## CATALOG PRODUCT NOTIFICATION

Date:	March 1, 2017					
Customer Part Number:	732-4224-5-ND, 732- 4230-5-ND	Wurth Electronics Midcom Part Number:	744861018, 744861250			
Customer Name:	digi-key	Wurth Electronics Midcom Inside Sales Rep:				
Customer Contact:						
➢ Product/Process Change ☐ Product Termination						
Internal Update						
Description and Purpose of Change(s):						
Change wire insulation from 155C to 180C						
Change tube packaging to plastic tray package. To improve packaging quality and better protect goods.						
From old tube packaging:						
ME - REPRESENTATION OF TAXABLE REALISING AND						
			Statement of the local division of the local			
The second						
A PROPERTY OF A CALLER A RANGE AND A RANGE

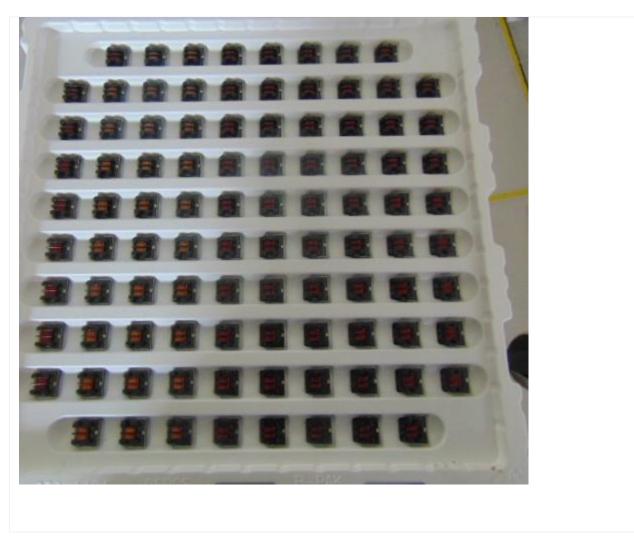
To new plastic tray packaging:

**Impact on Form, Fit, Function, Quality or Reliability**: The upgrade to high temperature wire insulation will have no effect on Form, Fit or Function. To prevent the core crack and offer better protection and improve package quality. TQ/BQ will be change to TQ: 96 PCS/TRAY BQ: 672PCS/BOX from TQ: 29PCS / TUBE and BQ: 725PCS/ BOX.
